Response to Submissions Report  
New Primary School at Murrumbateman  
SSD-11233241

On behalf of  
NSW Department of Education  
August 2021

**Figure 3:** Pedestrian path connecting to development to west (Source: Pedavoli site plan with Mecone mark-up)

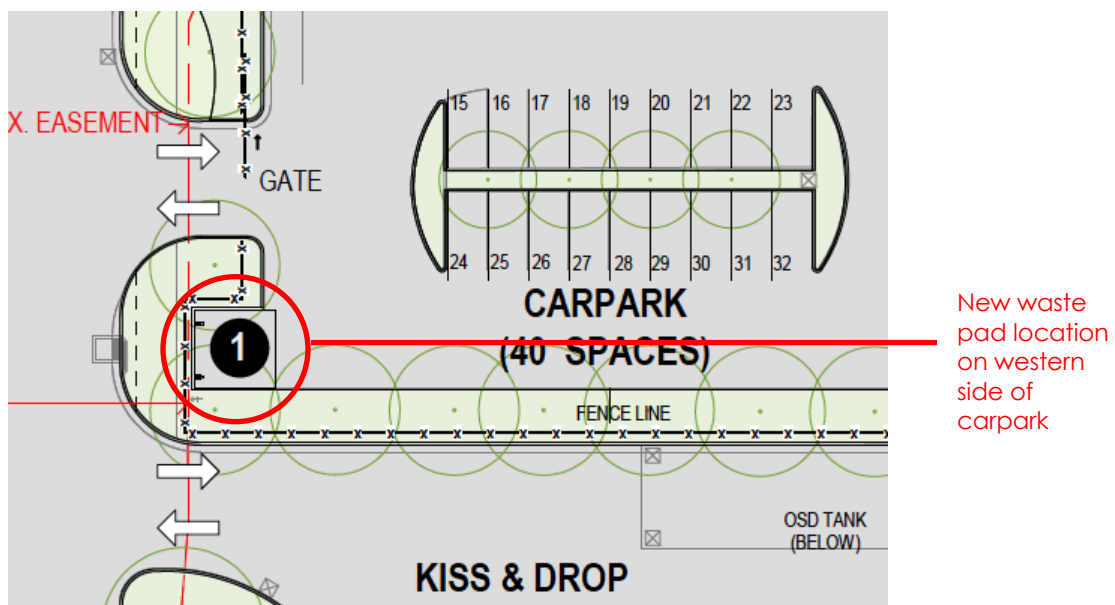
3. Adjust school entrance to include a path to the future commercial development to the west.	This change was made in response to a public submission. See Section 7 below.  The new pathway will connect along the site's western boundary near the main school entrance, outside of the school gates.  Refer to updated architectural plans and landscape plans at Appendices 1 and 2, respectively. Also see extract at Figure 3 below the table.

**Figure 4:** New waste pad location (Source: Pedavoli site plan with Mecone mark-up)

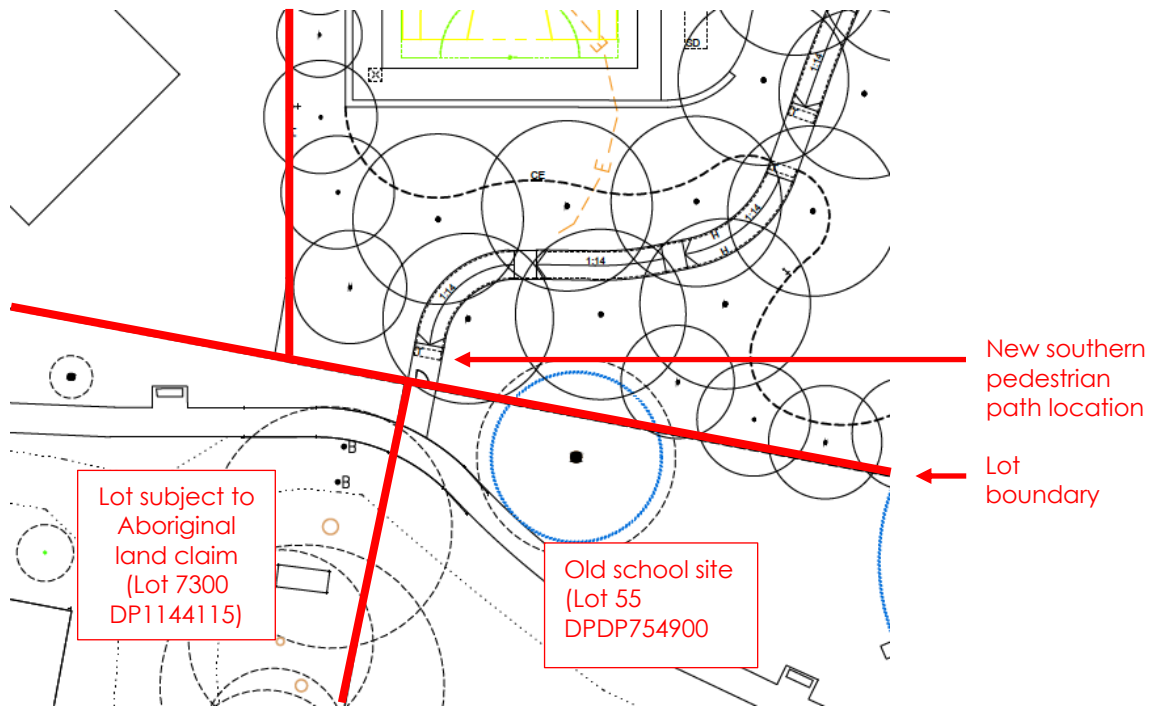
11. Revise layout of car park and relocate waste pad from eastern to western side of carpark	<p>The waste pad is moving to improve access and servicing by an 11m waste collection vehicle.</p> <p>Refer to updated civil plans at Appendix 10 and extract at Figure 4 below the table.</p> <p>Also refer to updated waste management plan is attached at Appendix 11.</p>

**Figure 5:** Revised southern pedestrian path (Source: TaylorBrammar landscape plan with Mecone mark-up)

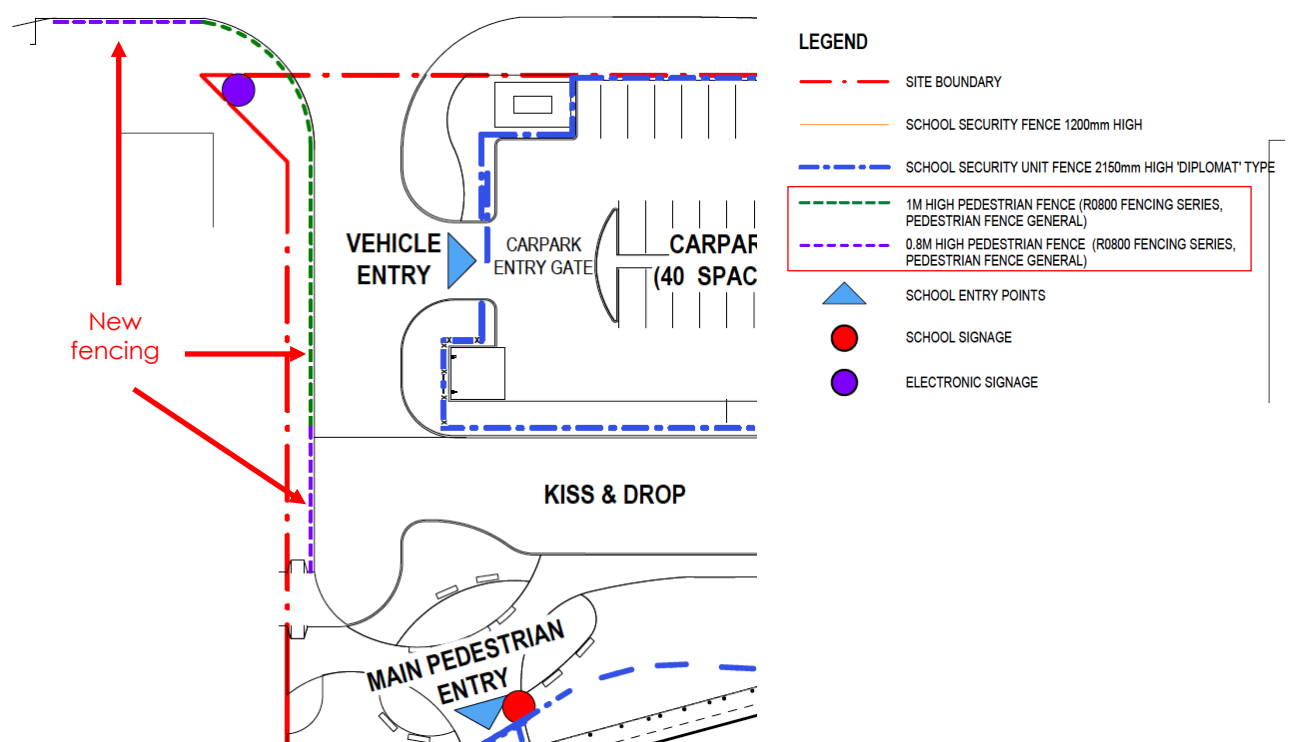
12. Adjust southern pedestrian entrance path so that it enters from the old school site rather than the site subject to the Aboriginal land claim, and bike storage moved to behind Building C	<p>Changes made in response to comments from Council. See Section 5.1 below.</p> <p>Refer to updated architectural and landscape plans at Appendices 1 and 2, respectively. Also see extract at Figure 5 below the table.</p>

Issue/comment	Response
Street to support the buses and other vehicles turning right at this location.	
<b>South pedestrian entry</b>	
This entry location is subject to resolution of the existing Aboriginal Land Claim over the Crown Land where there is an existing pedestrian path. From our discussions with NSW Crown Lands, it is understood it applies to LOT:7300 DP:114411. In the event that this claim is successful, access from this point is not available.	The southern pedestrian pathway has been adjusted so that it leads to the old school site (Lot 55 DPDP754900) rather than the lot subject to the Aboriginal land claim (Lot 7300 DP1144115).
While locating an entry here provides connectivity into the older established part of the Murrumbateman community, the location of the bicycle parking/storage adjacent to the southern gate presents a security concern, as there will be no surveillance of this area- particularly during class times. It is suggested that this bicycle parking be relocated adjacent to Block C.	The bicycle parking has been relocated to the south of Building C as recommended by Council.
